SERVICE BULLETIN

SERVICE BULLETIN		No.: MSB-99E22-001	
	Date: 1999-11-15	<Model>	<M/Y>
Subject:	CHANGE IN POSITION OF PAINT MARKS ON M/T SHIFT AND SELSECT CABLE ASSEMBLY	GALANT(EA0)	97-10
Group:	MANUAL TRANSAXLE	Draft No.: 99AL021617	
INFORMATION	OVERSEAS SERVICE DEPT	 T.NITTA - VICE GENERAL MANAGER QUALITY INFORMATION ANALYSIS

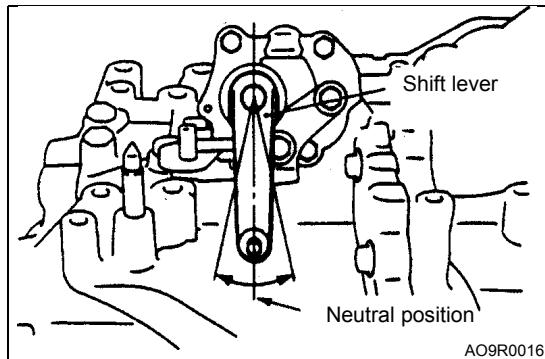
Paint marks on the M/T shift and select cable assembly have been changed in position in order for the marks to be more clearly seen after installation of the assembly has been done.

► A ◀ SHIFT CABLE AND SELECT CABLE ASSEMBLY/SHIFT CABLE CONNECTION/SELECT CABLE CONNECTION

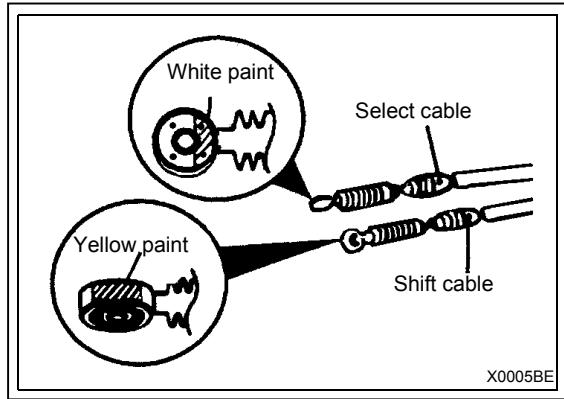
<Old>

- For the transmission side, the white and yellow paint marks on the shift and select cable ends should face the snap pins.

<New>

Install the transmission side shift cable with its end painted yellow toward the body top end. Install the transmission side select cable with its end painted white toward the snap pin end.
